DAVIS-BESSE IMPROVED TECHNICAL SPECIFICATIONS CONVERSION

ITS SECTION 3.0 LCO and SR APPLICABILITY

ITS Section 3.0, LCO and SR Applicability

**Current Technical Specification (CTS) Markup
and Discussion of Changes (DOCs)**

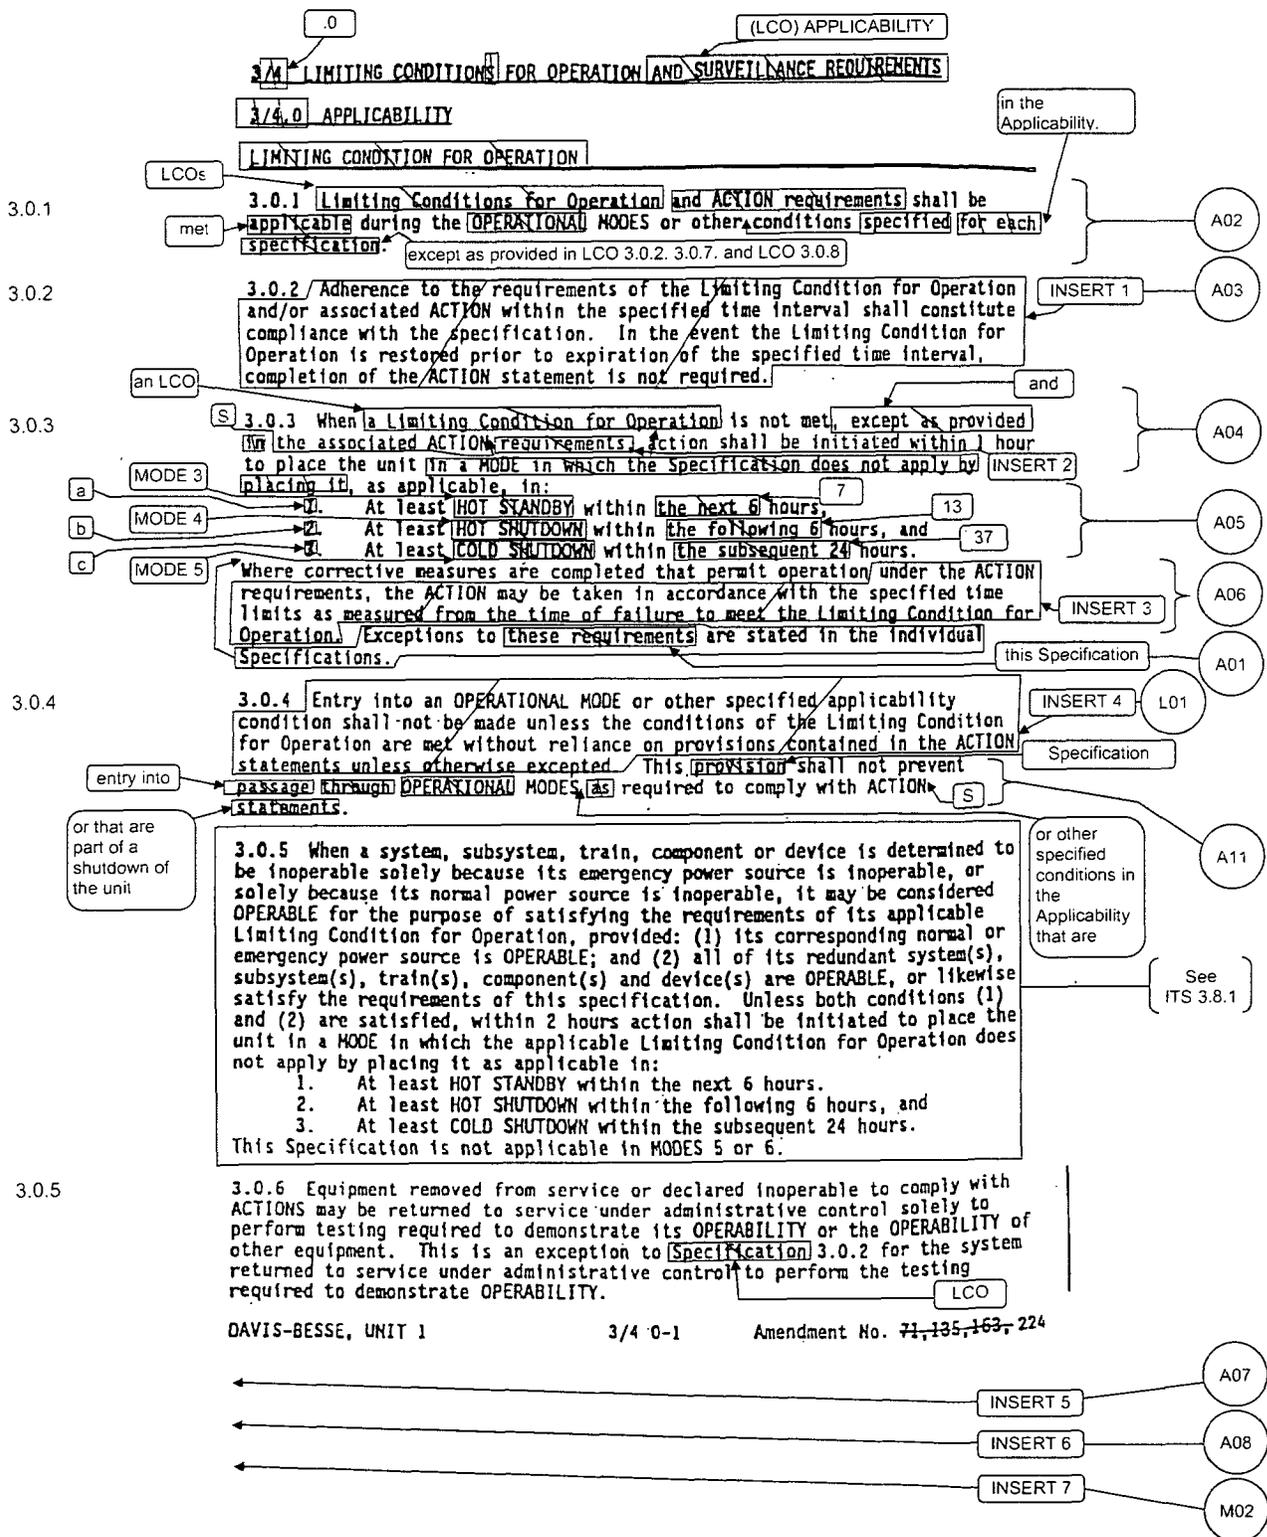
Upon discovery of a failure to meet an LCO, the Required Actions of the associated Conditions shall be met, except as provided in LCO 3.0.5 and LCO 3.0.6.

If the LCO is met or is no longer applicable prior to expiration of the specified Completion Time(s), completion of the Required Action(s) is not required, unless otherwise stated.

are not met, an associated ACTION is not provided, or if directed by the associated ACTIONS, the unit shall be placed in a MODE or other specified condition in which the LCO is not applicable.

in accordance with the LCO or ACTIONS, completion of the actions required by LCO 3.0.3 is not required.

LCO 3.0.3 is only applicable in MODES 1, 2, 3, and 4.

When an LCO is not met, entry into a MODE or other specified condition in the Applicability shall only be made:

- a. When the associated ACTIONS to be entered permit continued operation in the MODE or other specified condition in the Applicability for an unlimited period of time;
- b. After performance of a risk assessment addressing inoperable systems and components, consideration of the results, determination of the acceptability of entering the MODE or other specified condition in the Applicability, and establishment of risk management actions, if appropriate; exceptions to this Specification are stated in the individual Specifications; or
- c. When an allowance is stated in the individual value, parameter, or other Specification.

When a supported system LCO is not met solely due to a support system LCO not being met, the Conditions and Required Actions associated with this supported system are not required to be entered. Only the support system LCO ACTIONS are required to be entered. This is an exception to LCO 3.0.2 for the supported system. In this event, an evaluation shall be performed in accordance with Specification 5.5.14, "Safety Function Determination Program (SFDP)." If a loss of safety function is determined to exist by this program, the appropriate Conditions and Required Actions of the LCO in which the loss of safety function exists are required to be entered.

When a support system's Required Action directs a supported system to be declared inoperable or directs entry into Conditions and Required Actions for a supported system, the applicable Conditions and Required Actions shall be entered in accordance with LCO 3.0.2.

LCO 3.0.7 Test Exception LCOs 3.1.8 and 3.1.9 allow specified Technical Specification (TS) requirements to be changed to permit performance of special tests and operations. Unless otherwise specified, all other TS requirements remain unchanged. Compliance with Test Exception LCOs is optional. When a Test Exception LCO is desired to be met but is not met, the ACTIONS of the Test Exception LCO shall be met. When a Test Exception LCO is not desired to be met, entry into a MODE or other specified condition in the Applicability shall be made in accordance with the other applicable Specifications.

LCO 3.0.8 When one or more required snubbers are unable to perform their associated support function(s), any affected supported LCO(s) are not required to be declared not met solely for this reason if risk is assessed and managed, and:

- a. the snubbers not able to perform their associated support function(s) are associated with only one train or subsystem of a multiple train or subsystem supported system or are associated with a single train or subsystem supported system and are able to perform their associated support function within 72 hours; or
- b. the snubbers not able to perform their associated support function(s) are associated with more than one train or subsystem of a multiple train or subsystem supported system and are able to perform their associated support function within 12 hours.

At the end of the specified period the required snubbers must be able to perform their associated support function(s), or the affected supported system LCO(s) shall be declared not met.

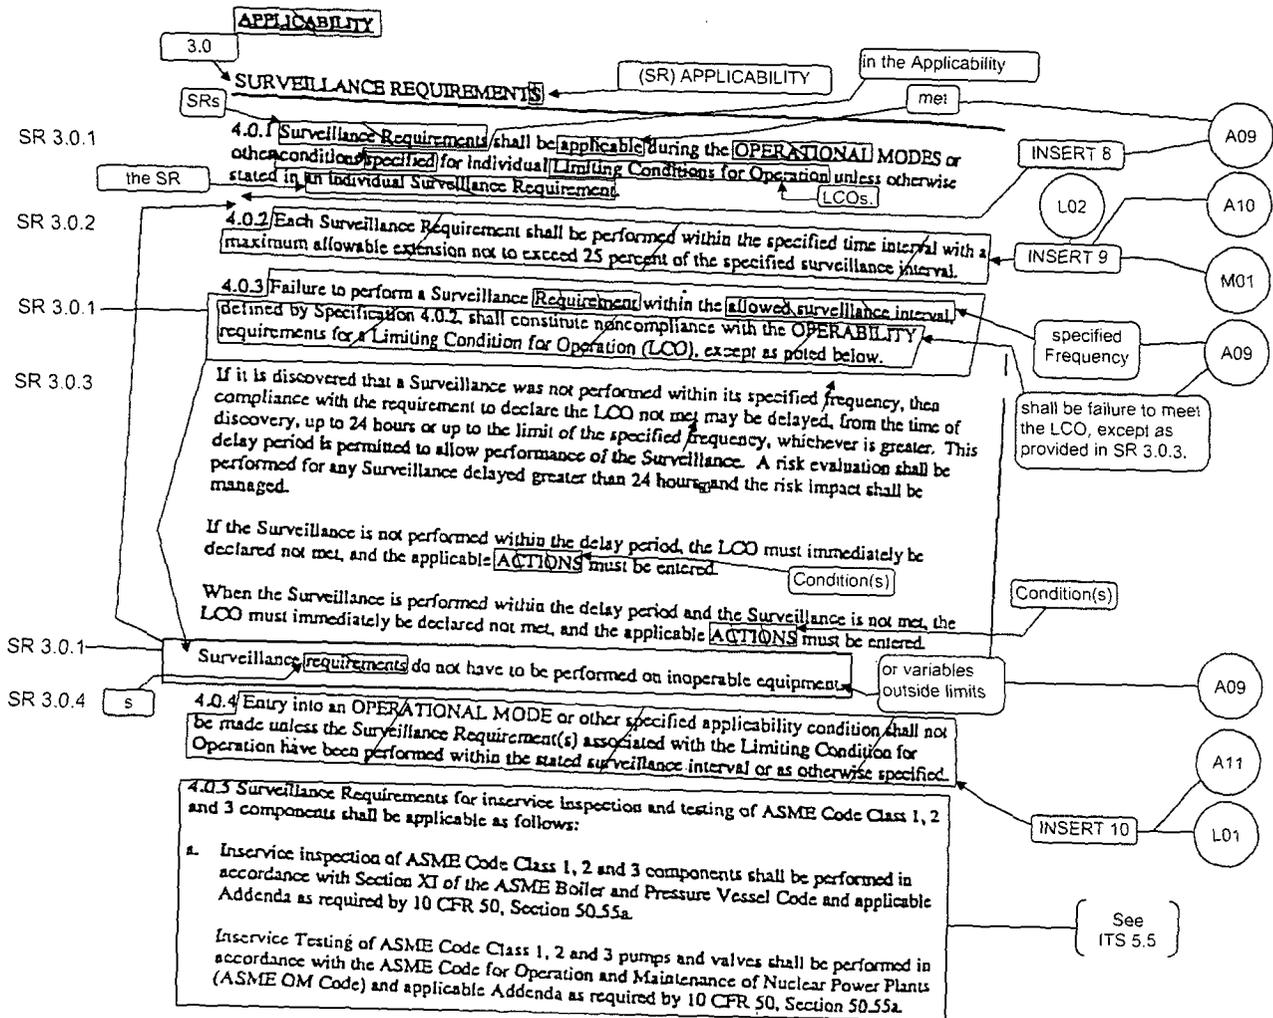
Failure to meet a Surveillance, whether such failure is experienced during the performance of the Surveillance or between performances of the Surveillance, shall be failure to meet the LCO.

The specified Frequency for each SR is met if the Surveillance is performed within 1.25 times the interval specified in the Frequency, as measured from the previous performance or as measured from the time a specified condition of the Frequency is met.

For Frequencies specified as "once," the above interval extension does not apply.

If a Completion Time requires periodic performance on a "once per . . ." basis, the above Frequency extension applies to each performance after the initial performance.

Exceptions to this Specification are stated in the individual Specifications.

Entry into a MODE or other specified condition in the Applicability of an LCO shall only be made when the LCO's Surveillances have been met within their specified Frequency, except as provided by SR 3.0.3. When an LCO is not met due to Surveillances not having been met, entry into a MODE or other specified condition in the Applicability shall only be made in accordance with LCO 3.0.4.

This provision shall not prevent entry in MODES or other specified conditions in the Applicability that are required to comply with ACTIONS or that are part of a shutdown of the unit.

BASES

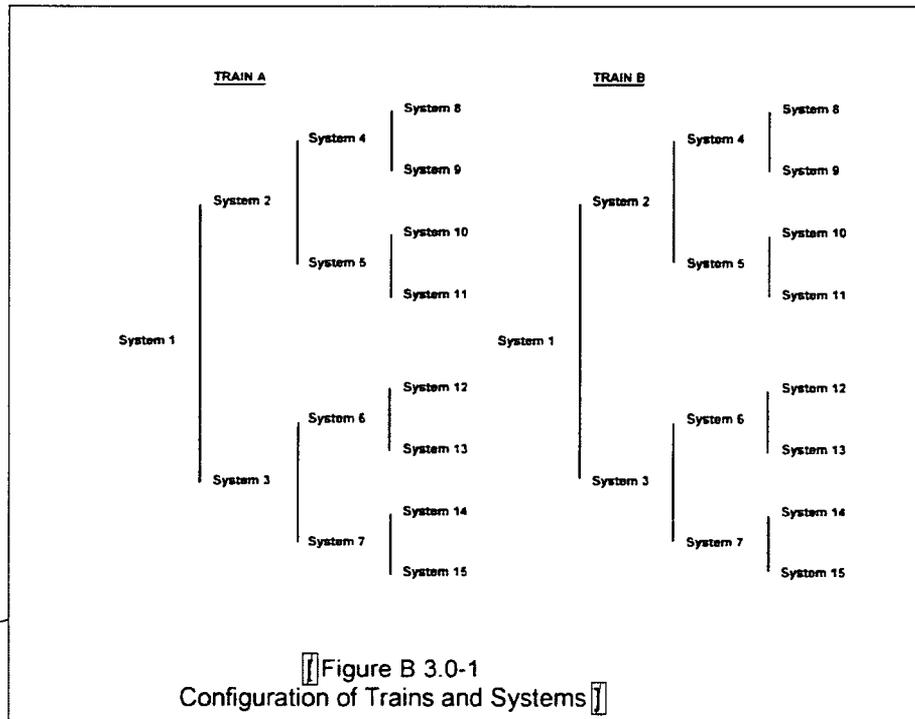
(move to end
of Section)

6. The Figure has been moved to the end of the Section, consistent with the format of the ITS.
7. These changes are made to be consistent with LCO 3.0.7.
